Historic Preservation Commission

MEETING NOTICE

To: Historic Preservation Commission Members
From: Adam Lindenlaub, Community Development Planner
Subject: COA Request at 525 Valor Way SW
Date: May 27, 2021

To: Historic Preservation Commission Members
From: Jeff Wozencraft, Community Development Planner
Subject: COA Request at 1829 Ridgewood Terrace SE
Date: May 27th, 2021

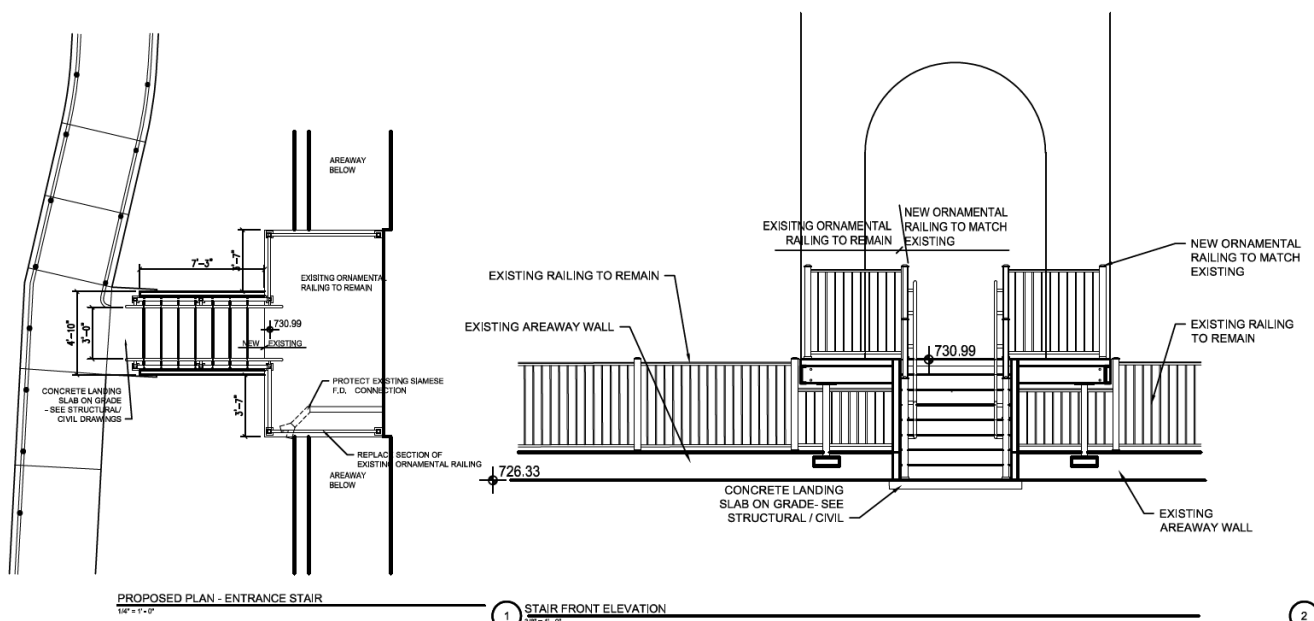
As previously discussed and held at the April 8th HPC meeting, alteration of the front staircase is due to the construction of the McGrath Amphitheatre restroom and storage facility located directly north of and adjacent to the property. Access improvements to the end of Valor Way require moving the Right-of-Way (ROW) line closer to the Chelsea building, which after receiving feedback at the April 22nd HPC meeting have led to the proposed addition of one step to the front stairs of the building. This will increase the number from six to seven as shown in the image below. Any existing railing removed will be replaced with the same ornamental railing as exists today.

Staff Recommendation: Staff recommends approving the Certificate of Appropriateness as the staircase is considered to be a non-historic element of the structure per the local landmark documentation and the historic alignment is maintained.

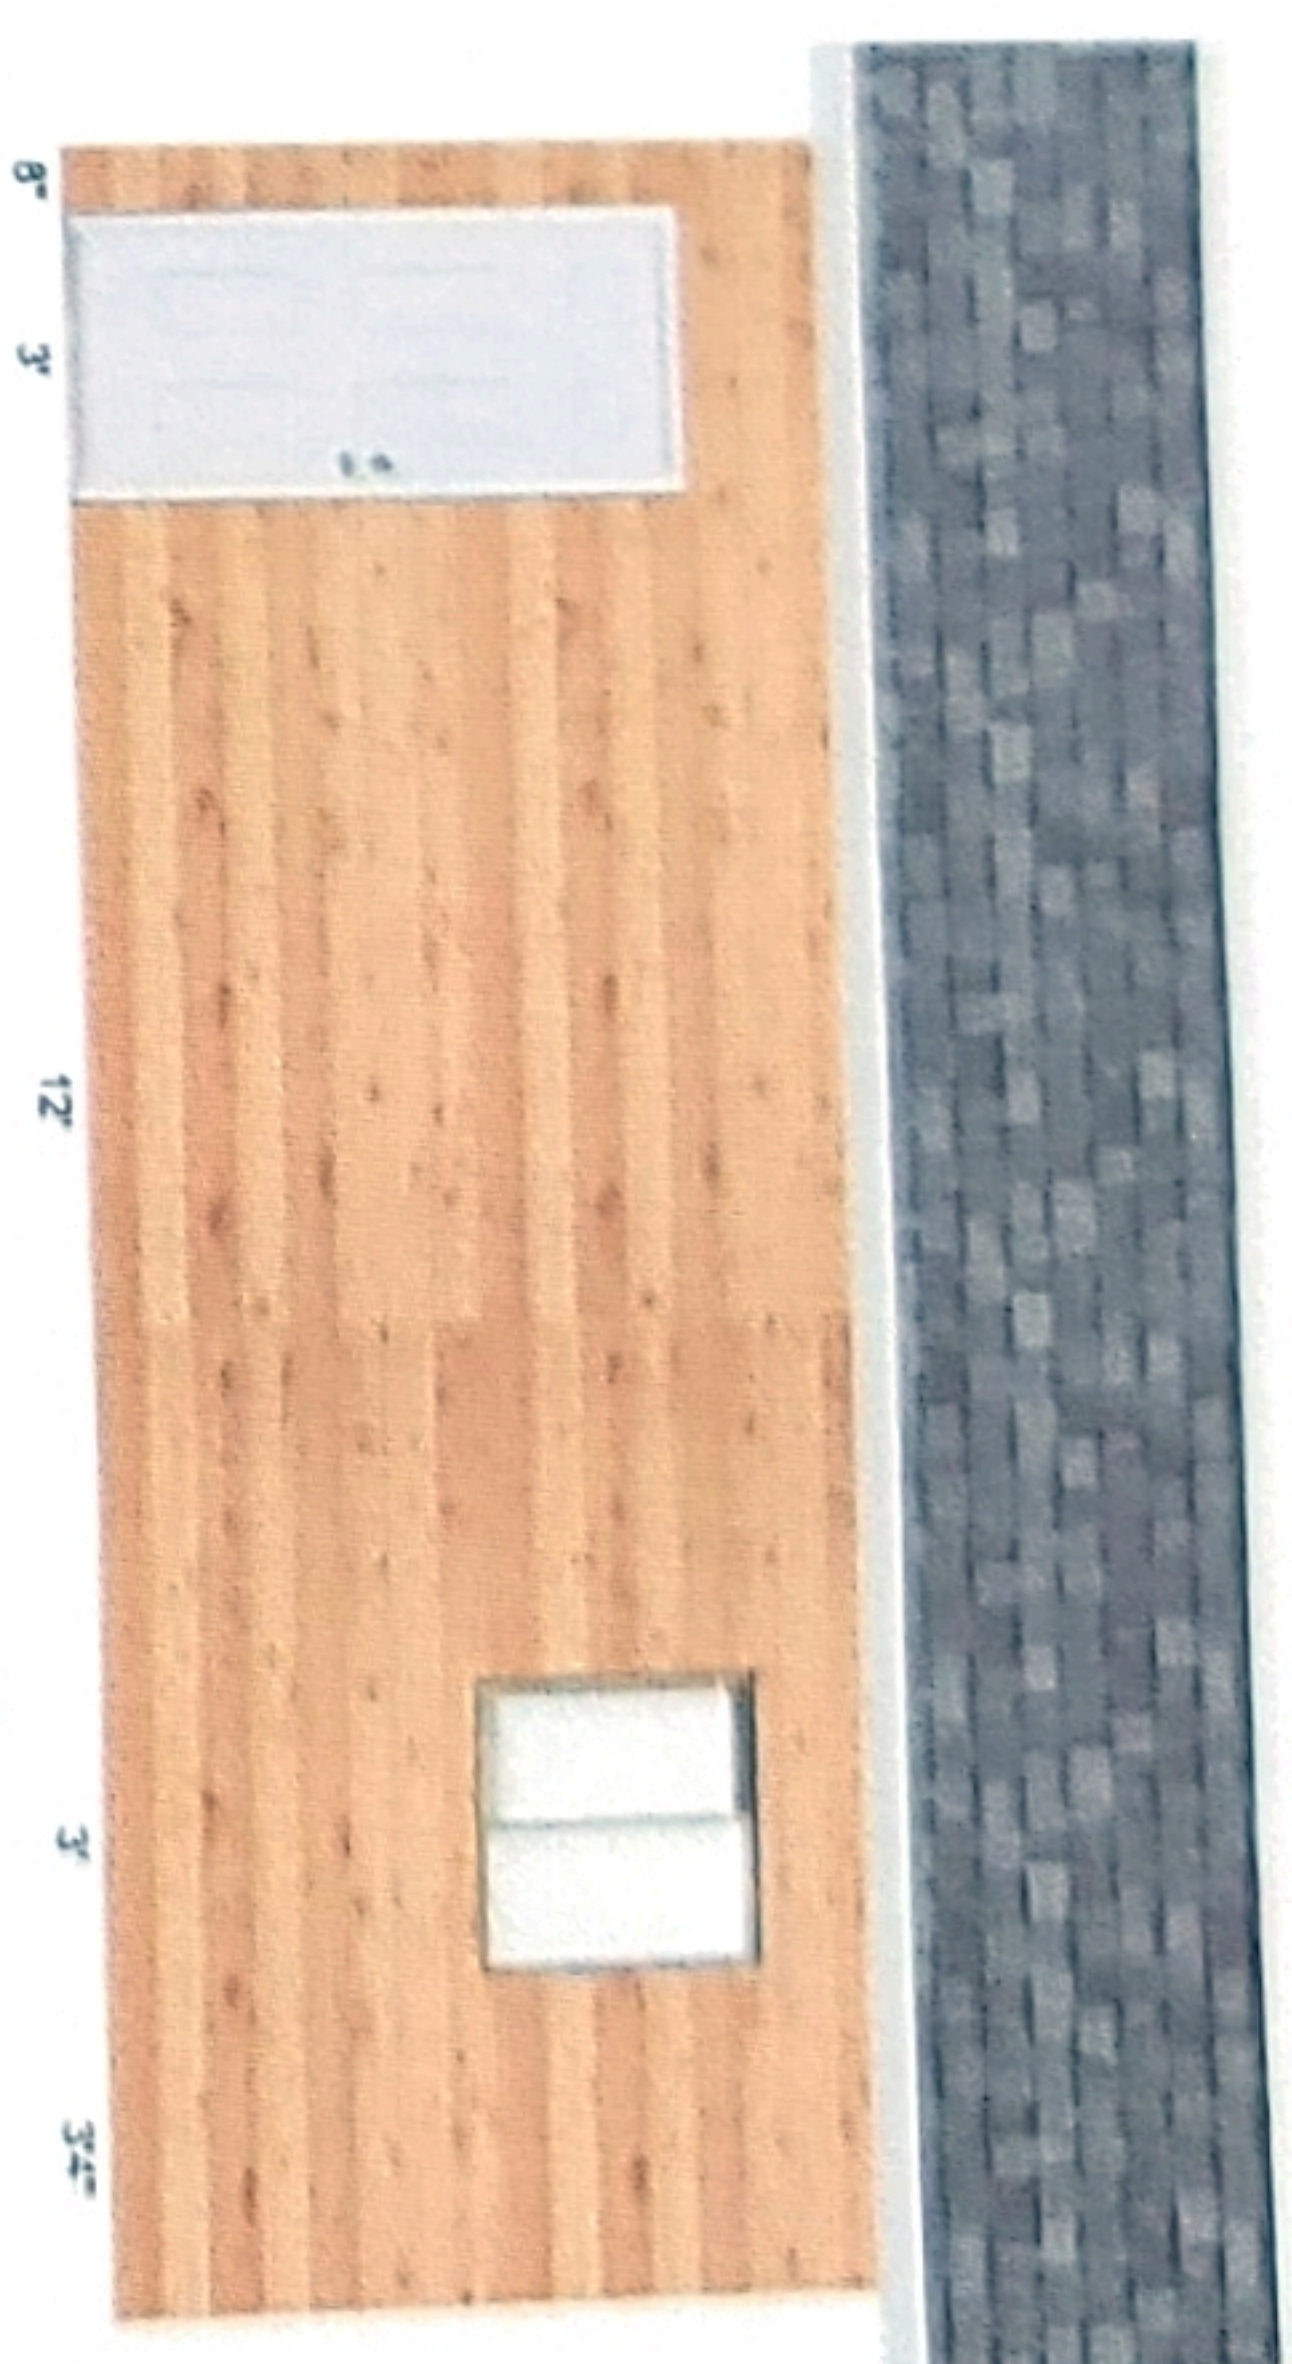
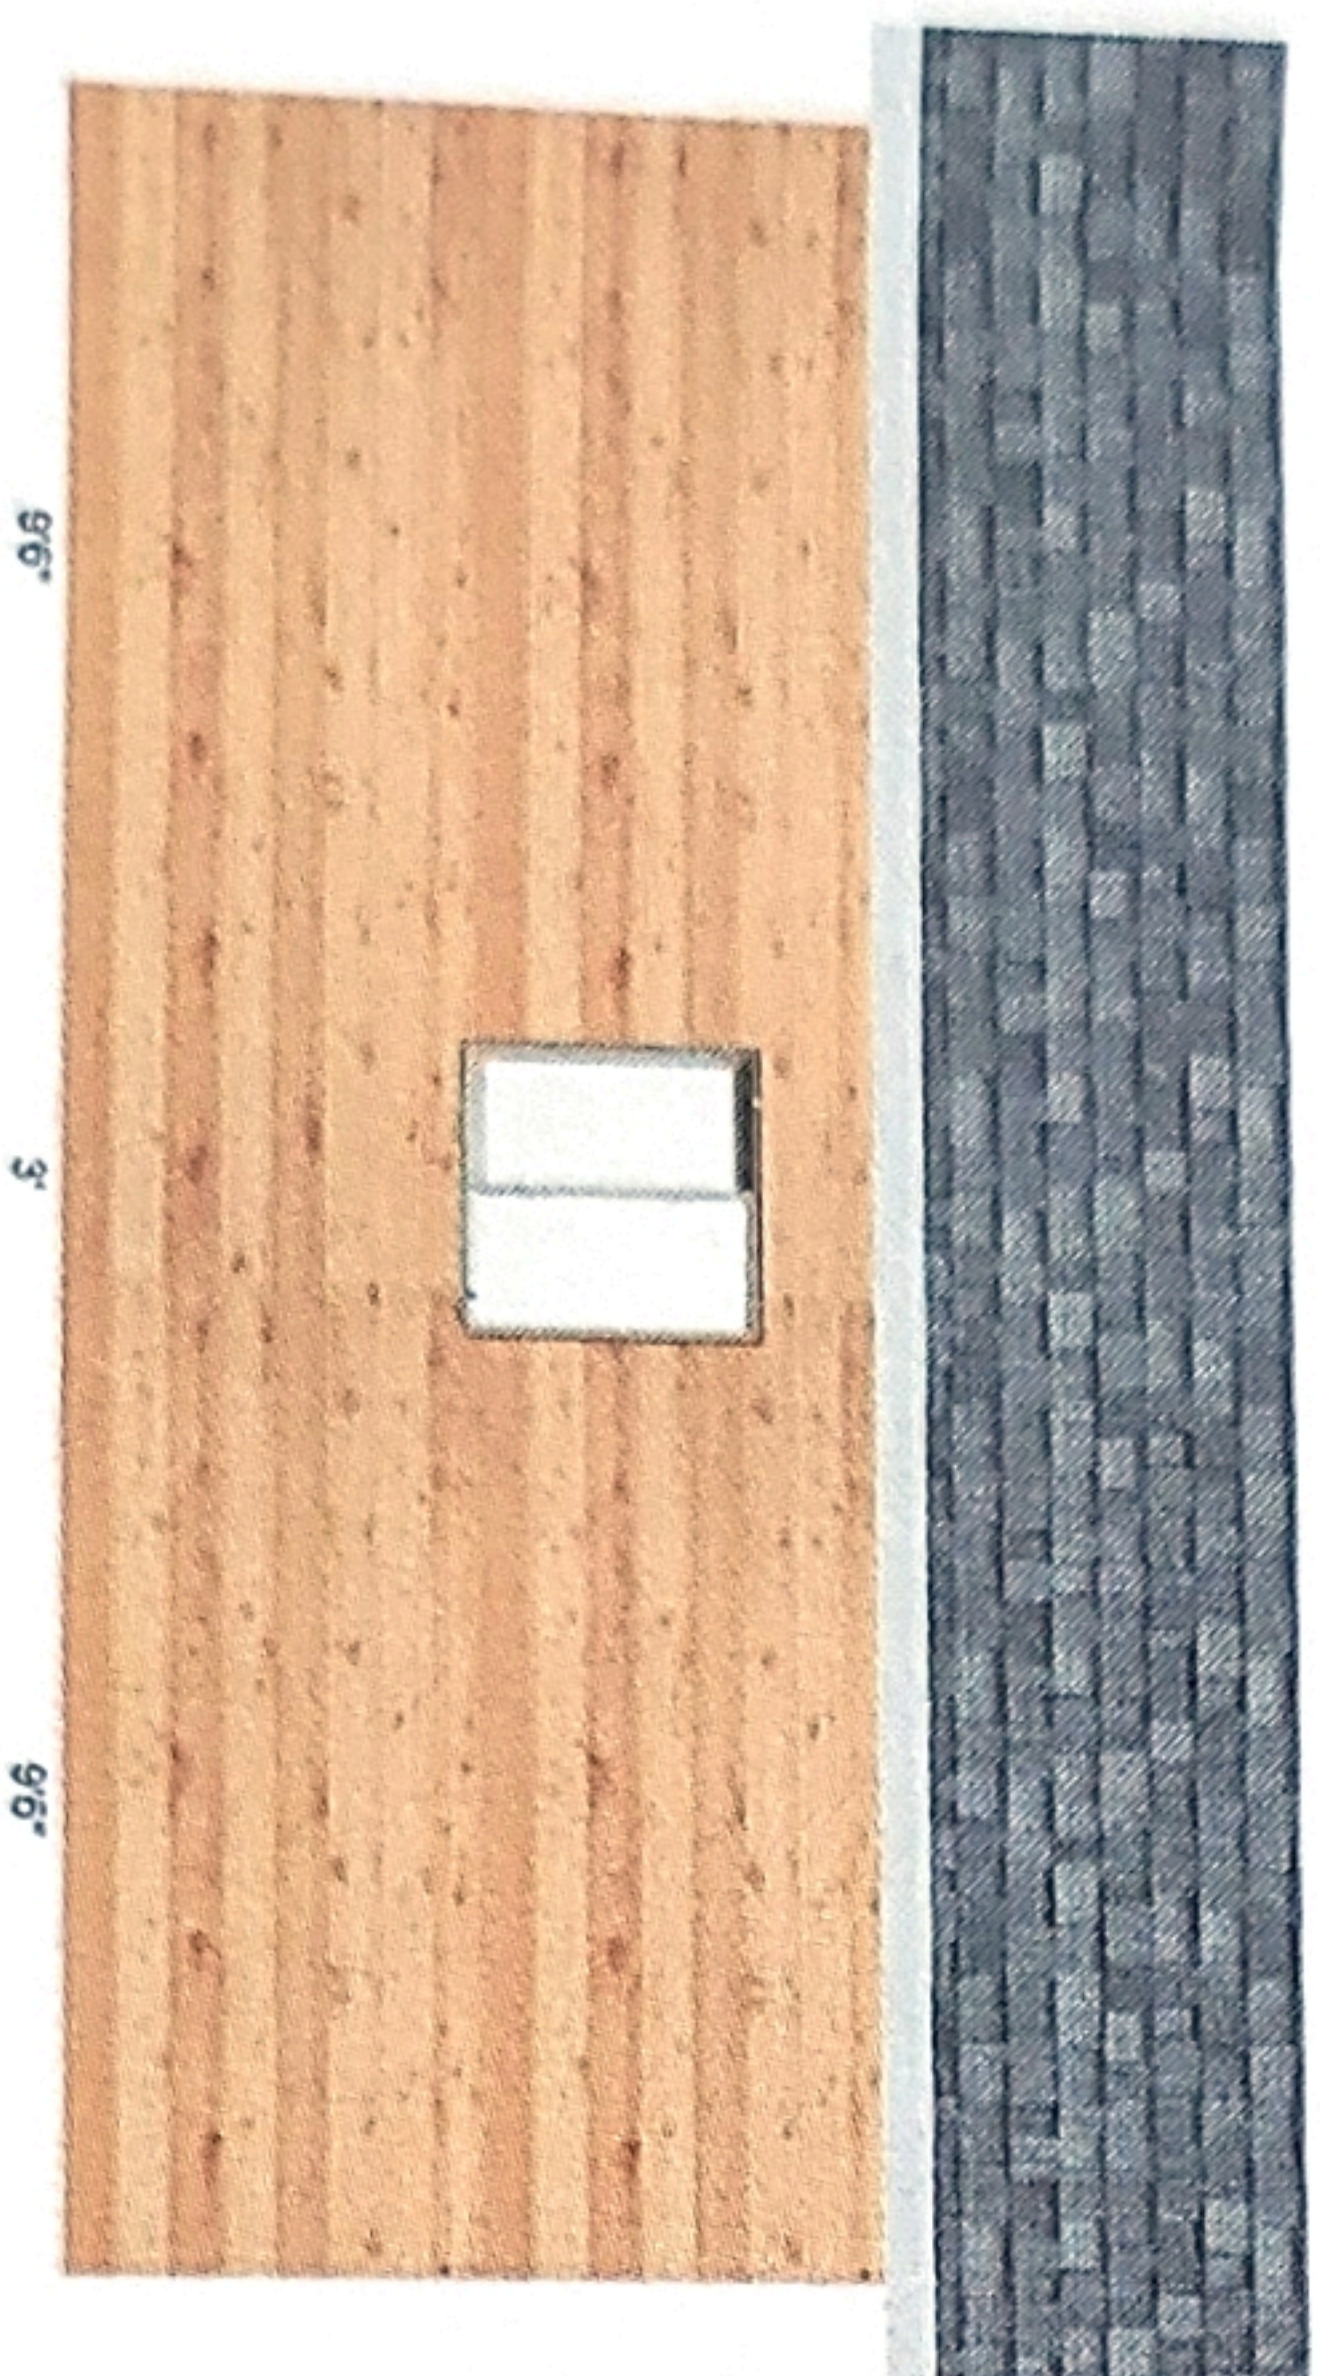
The applicant would like to rebuild a garage in the same spot as the one destroyed in Derecho. It will be on the south side of the property close to the alley. It will be constructed like the original with wood siding and roofing material to match the house. There will be three windows and one door as was in the original building. There will be a metal garage door facing the alley (south side). The windows will be vinyl and the door metal. The rest of the construction will be wood. There will be electricity run to the garage (like the original).

Staff Recommendation: Staff recommends approving the Certificate of Appropriateness for the new accessory structure because the materials propose will match the materials of the previous structure and the structure will be located in such a way that it is not visually prominent.
